PCN – Product Change Notification

PCN-A-120402

PCN Topic: Mechanical change of Winmate W22L100-PMM1

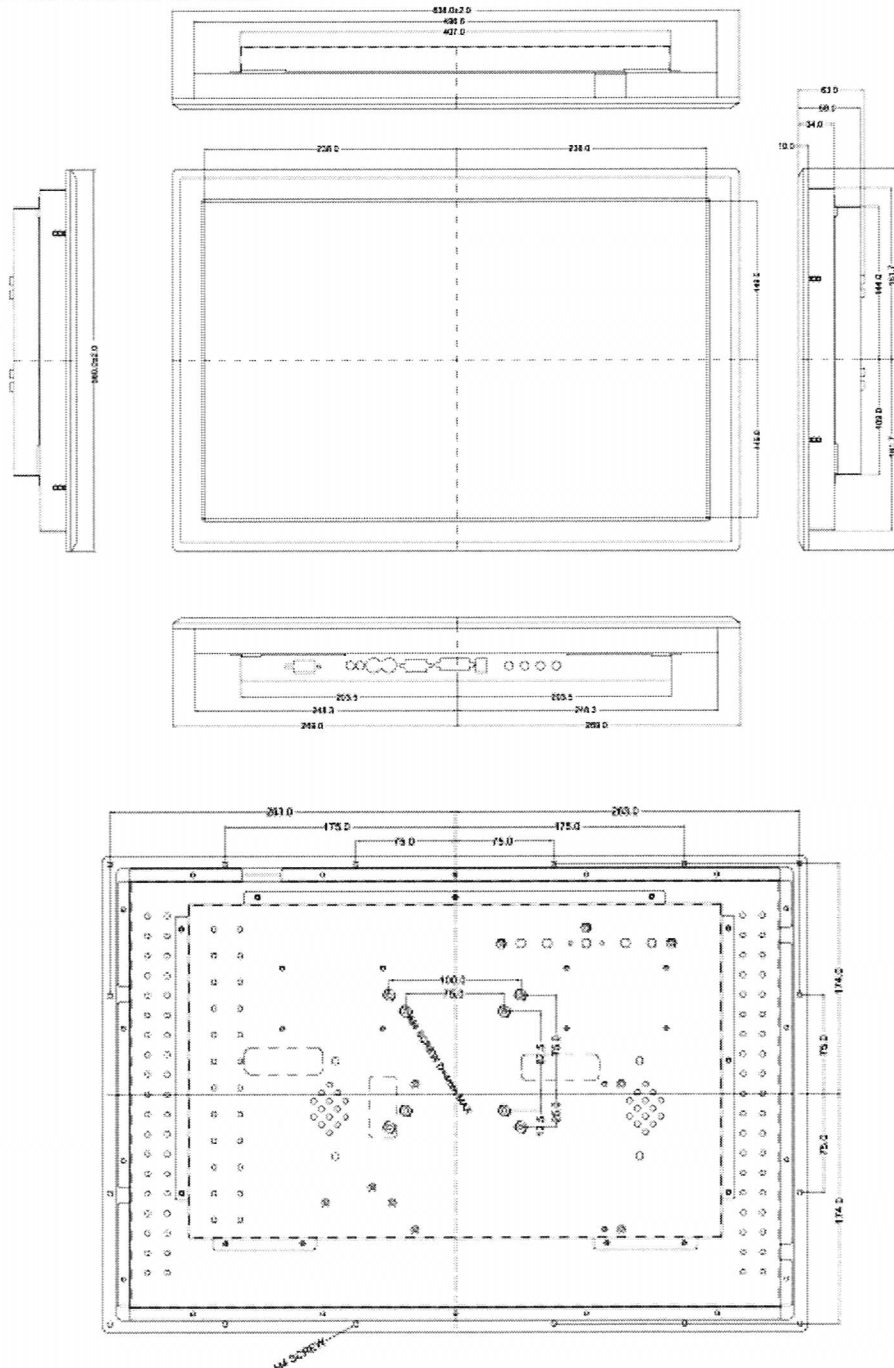
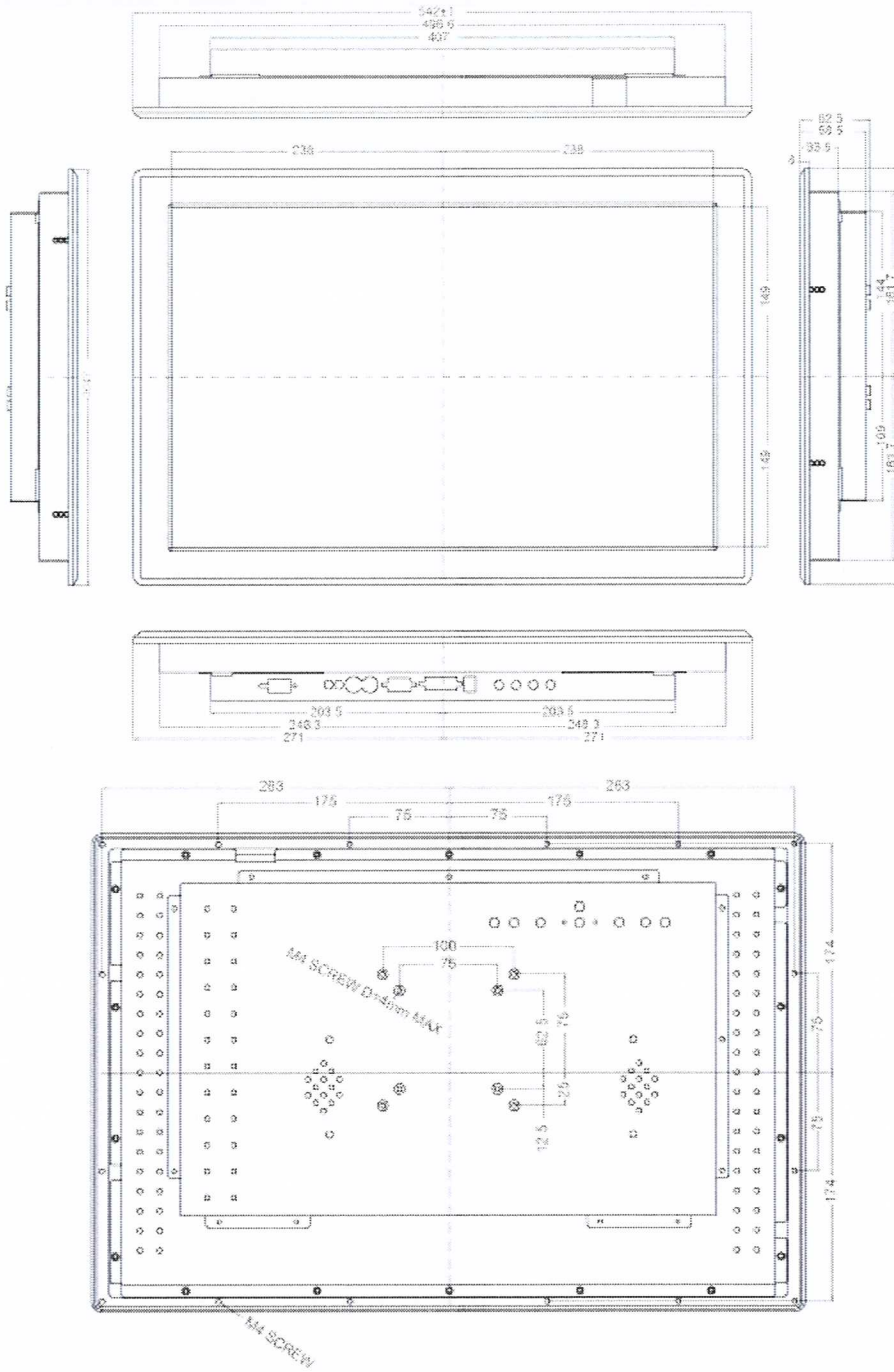
The dimension of Panel Mount (Standard) mechanical will change from 538 x 360 x 59 mm to 542X 364 X 58.5 mm. Panel Mount front bezel from 10mm to 8mm.

The below pictures show the example of how the new mechanic differ from Original one.
